**Origination Form**  
Proposed Revisions to a Standard Plans Index

<b>Originator:</b>	Stepp, Richard	<b>Index Number:</b>	102-110
<b>Date:</b>	10/18/2024	<b>Sheet Number(s):</b>	1,4, 7-10
<b>E-mail:</b>	richard.stepp@dot.state.fl.us	<b>Index Title:</b>	Type K Temporary Concrete Barrier System

LAST REVISION	DESCRIPTION:	FDOT	FY <del>2025-26</del> 2026-27	STANDARD PLANS	TYPE K TEMPORARY CONCRETE BARRIER SYSTEM	INDEX	SHEET
<del>11/01/17</del> 11/01/25						102-110	8 of 17

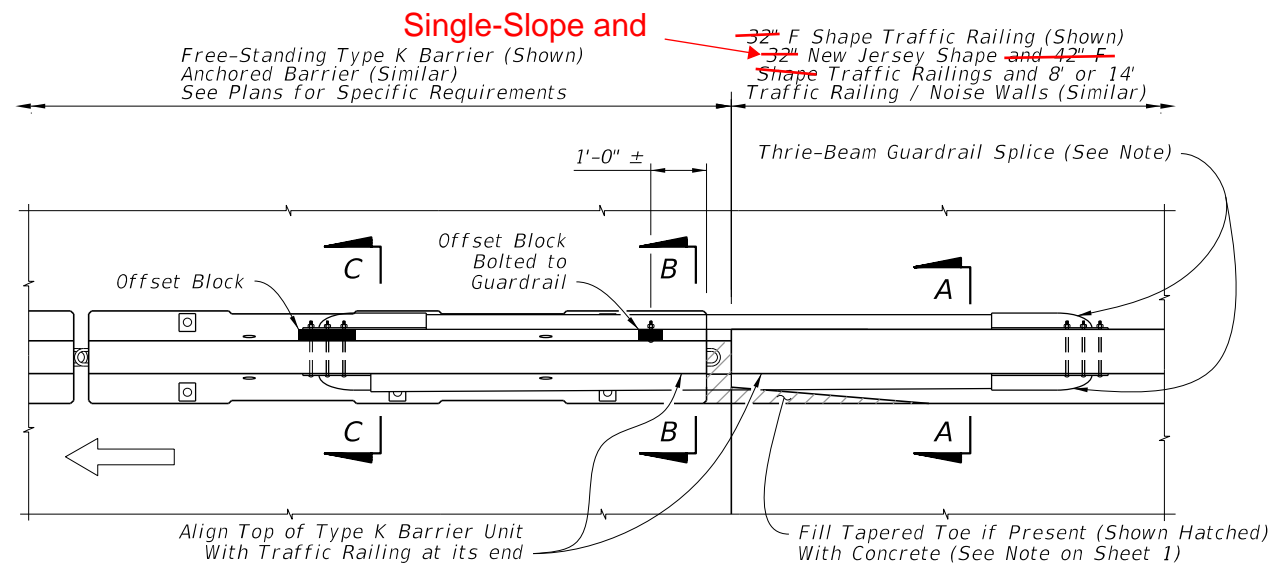
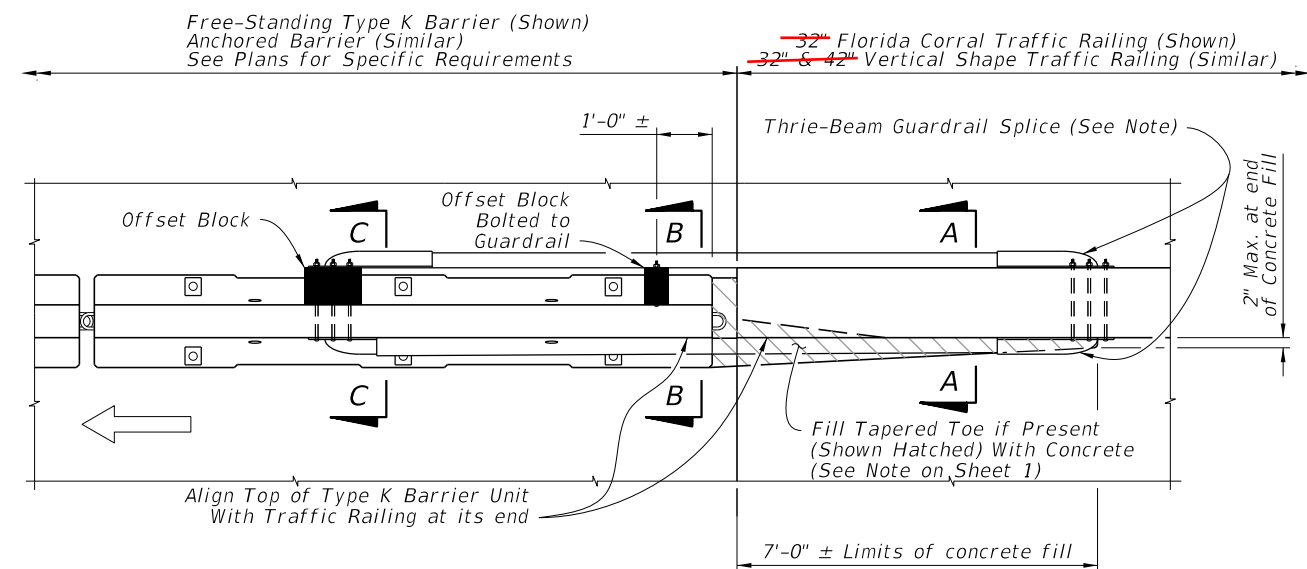
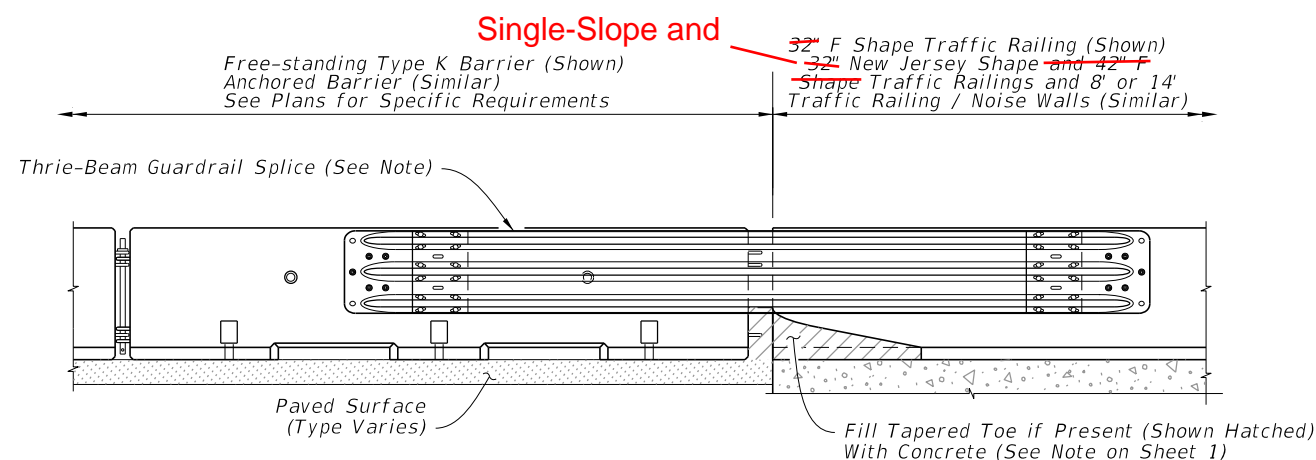
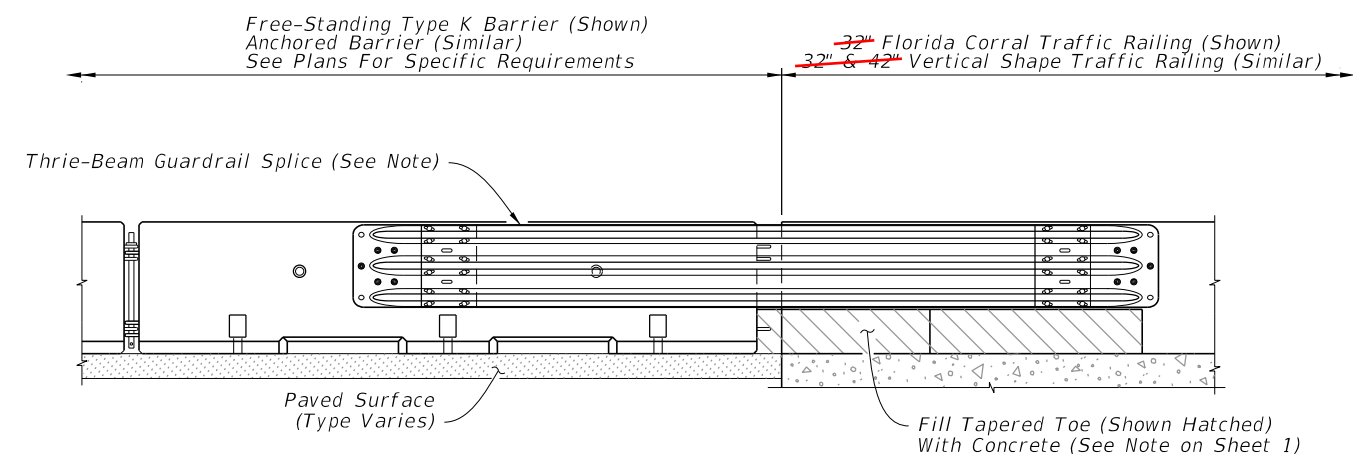
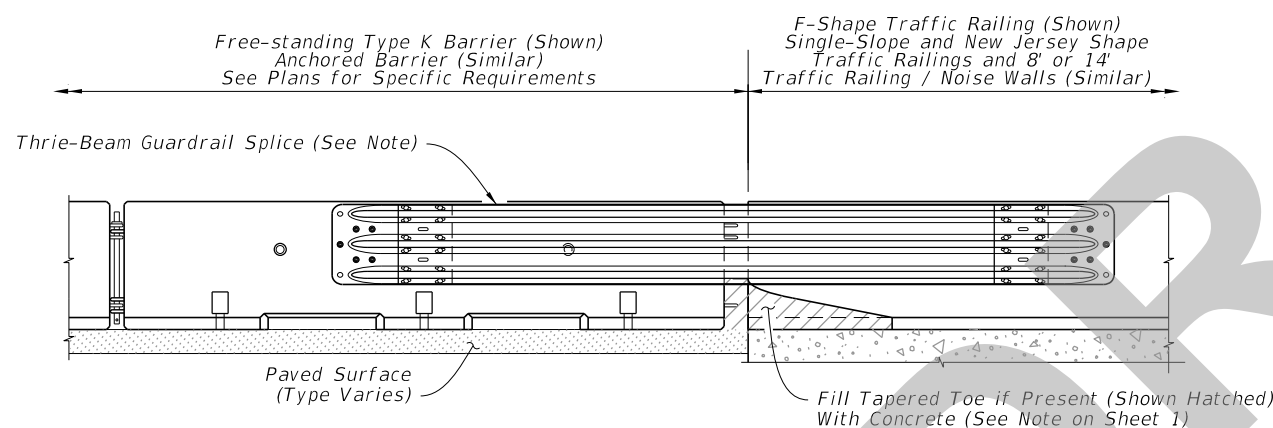
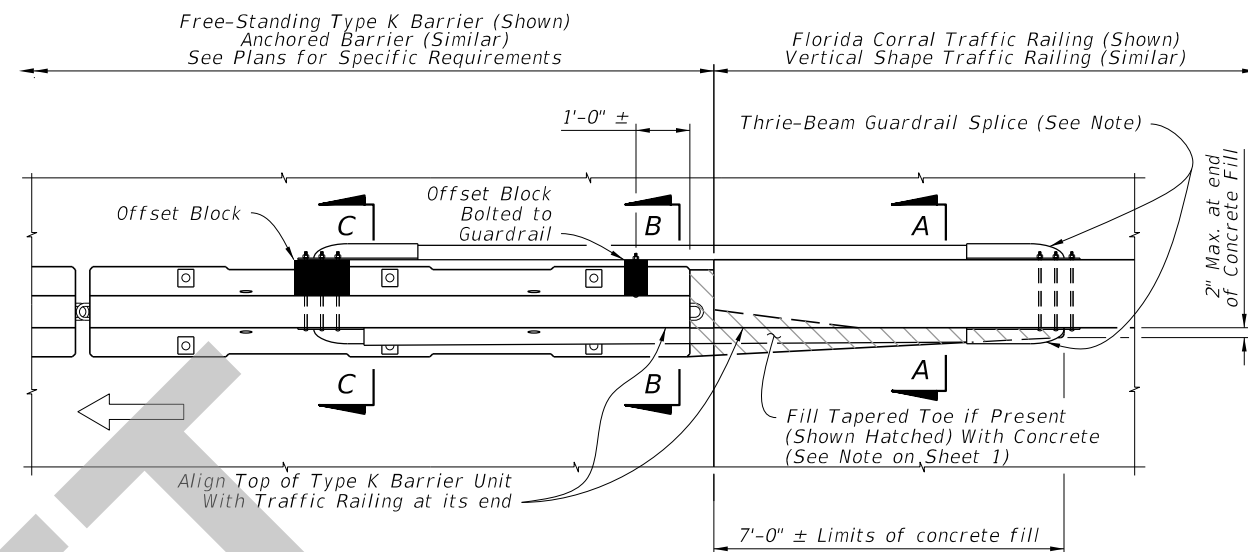
Sheets 7-10: Revised detail labels to simplify and include "Single-Slope" Traffic Railings and Concrete Barriers where applicable

For Single-Slope, F-Shape, ~~FOR F AND NEW JERSEY SHAPE TRAFFIC RAILINGS~~ AND 8' & 14' TRAFFIC RAILING / NOISE WALLS (Concrete Barrier Similar)

TRAILING END SPLICE DETAIL  
FOR SINGLE-SLOPE, F-SHAPE, AND NEW JERSEY SHAPE TRAFFIC RAILINGS AND 8' & 14'  
TRAFFIC RAILING / NOISE WALLS (CONCRETE BARRIER SIMILAR)
